Baseline Monitoring Report

Little River Ford Mitigation Site

Subject: MY0 Report Review

On March 15, 2023, Wildlands Engineering received comments from the North Carolina Division of Mitigation Services (DMS) regarding the Draft As-Built Baseline Report dated March 10, 2023. The following letter documents DMS feedback and Wildlands' corresponding responses and revisions to the As-Built Report.

Figure 3. Project Component/Asset Map Little River Ford Mitigation Site As-Built Report Neuse River Basin (03020201)

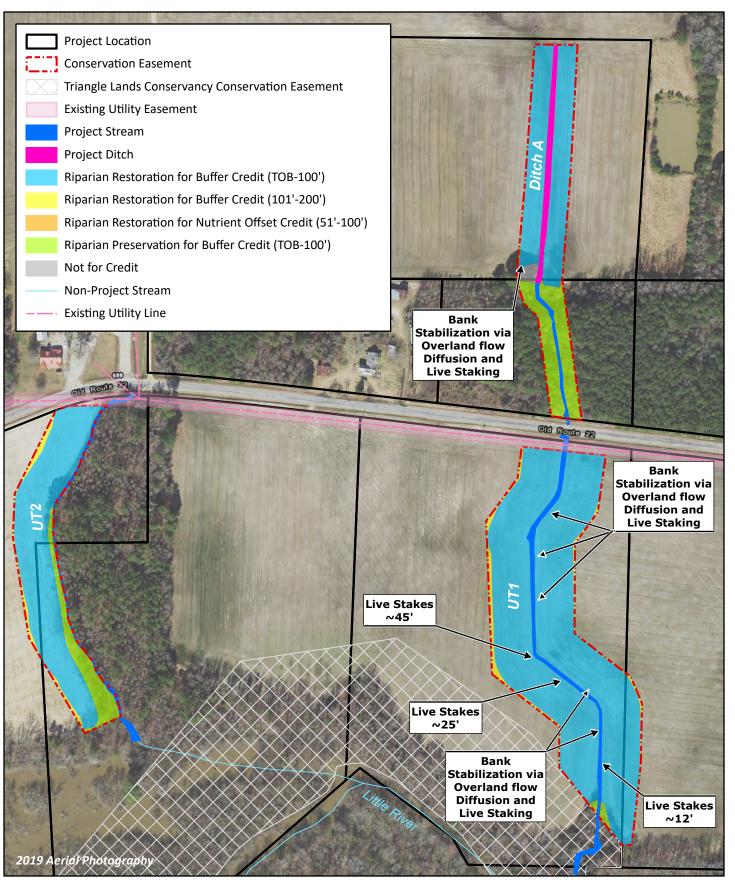
Please update the CCPV with a zoomed in area of the nutrient offset along Ditch A, it's difficult to see on the map.

Response: The update has been made.
